A380 South Devon Link Road (Kingskerswell Bypass)

Public Inquiry

**Devon County Council's Response to
Proofs of Evidence on behalf of the Kingskerswell Alliance**

(Obj45): OBJ/KA(45)/P/1, OBJ/KA(45)/P/2 and OBJ/KA(45)/P/3

Diagram 1: Comparison of ANPR data and Kingskerswell Alliance Journey Time Data

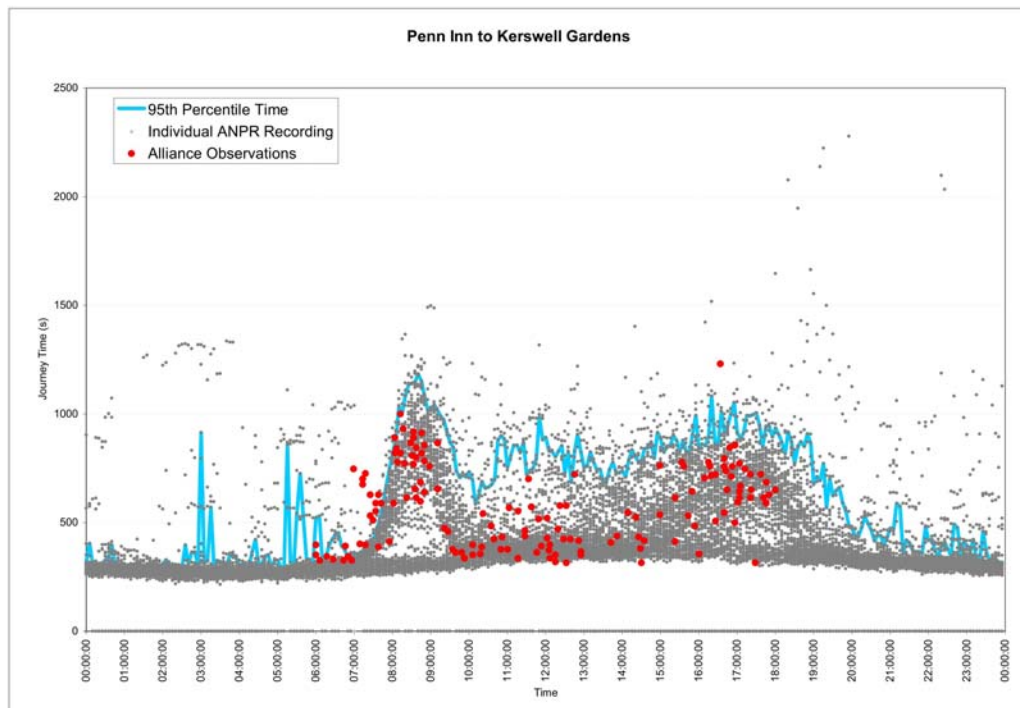
- 3.6 Comparison between the data given in DCC/P/4, Diagram 5 and the Kingskerswell Alliance journey time data has been made. The delay times given by the Kingskerswell Alliance have been converted to journey times by adding the free flow time (300 seconds) to each observation. The results can be seen below in Diagram 1.

- 3.7 It can be seen from the diagram that the Kingskerswell Alliance observations fall within the range of journey times observed using ANPR technology and therefore the two sources of data are consistent.
- 3.8 Due to the awareness of the impact the single lane section (and associated junctions) has on the A380 to the north, it is inappropriate to consider journey times between Penn Inn and Kerswell Gardens alone. As discussed, route journey times between Ware Cross and Kerswell Gardens have been given in DCC/P/4, Table 4; these show a more complete picture of the situation on the A380 and illustrate the current conditions on the A380, i.e. poor average journey times and poor journey time reliability.

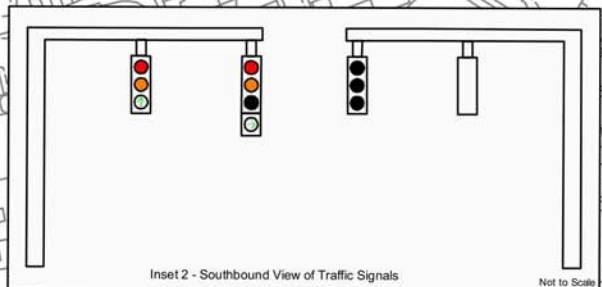
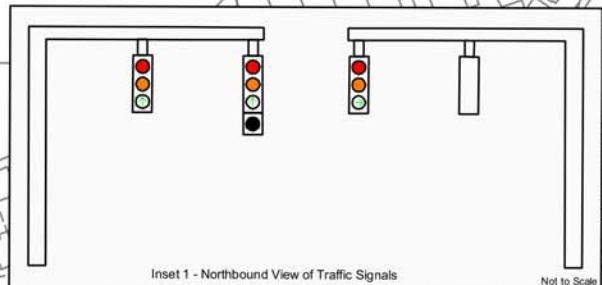
- 5.4 We consider that the use of gantries in Kingskerswell will be unsightly, not in keeping with the local environment and will most likely meet with opposition from local residents and businesses, especially those fronting the A380. The alternative of dynamic road markings would be an ideal solution to prevent the use of gantries. We accept that the use of dynamic road markings is still developing, however trials are being undertaken by the Highways Agency as well as other highway authorities in Europe. Their use in Kingskerswell would be ideal in developing innovative transport technologies.

5.5 There is an appreciation of the benefits of dynamic road markings for complex junctions and hard shoulder running. In these instances traffic is travelling in the same direction and there is additional signing. I would welcome sight of any further information on the trials.

Indicative Layout

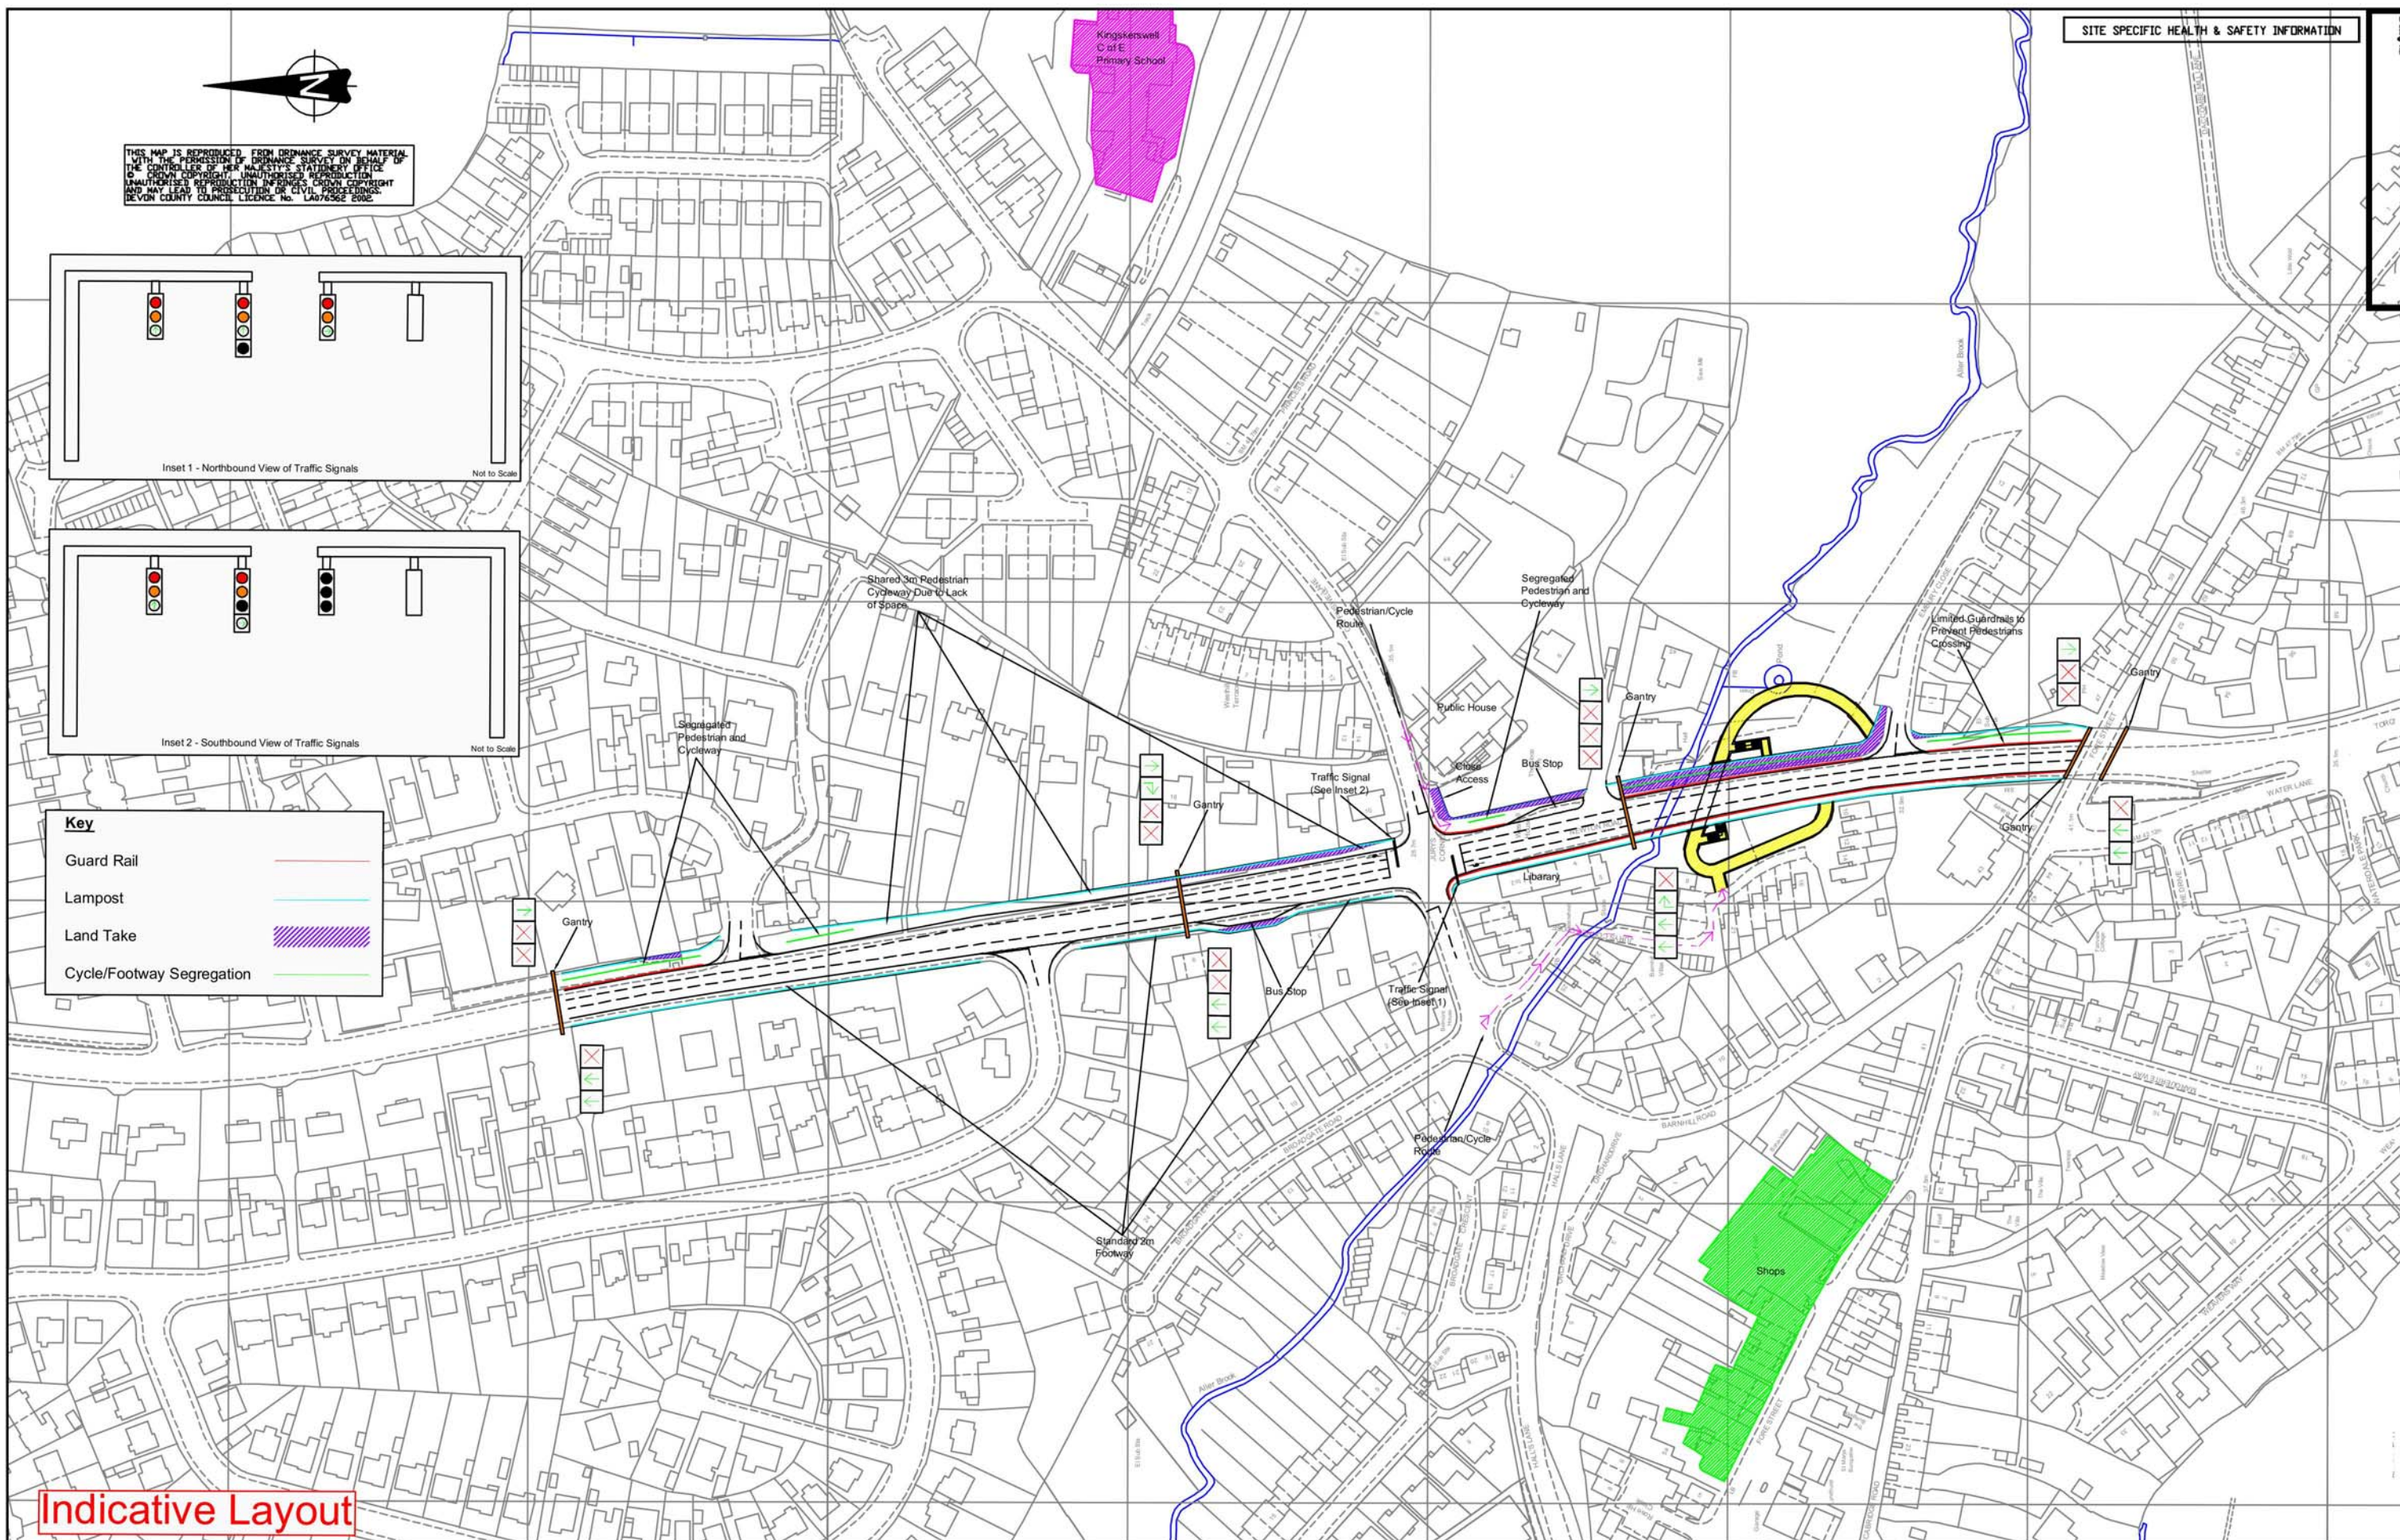
- 5.5 Devon County Council have endeavoured to work up an alternative which is realistic as possible given the constraints at the junction. Nevertheless, the scheme still has the following issues:

- Visual Intrusion - the scheme is not in keeping with the village environment;
 - Severance Issue - there will be a large detour for pedestrians / cyclists; which may encourage them to cross at the junction;

- Safety issue if pedestrians / cyclists do decide to cross;
 - Security of the pedestrian underpass, may be considered dangerous by users;
 - Land take is required for footways and bus bays;

- Discontinuous guard rails (driveways cannot be blocked) may further encourage crossings at Jurys Corner;
 - A continuous segregated footway / cycleway cannot be provided without additional land take;

- Gantries may possibly have to be placed in gardens. If a light weight version can be designed then could be placed in the already cramped footway / cycleway.
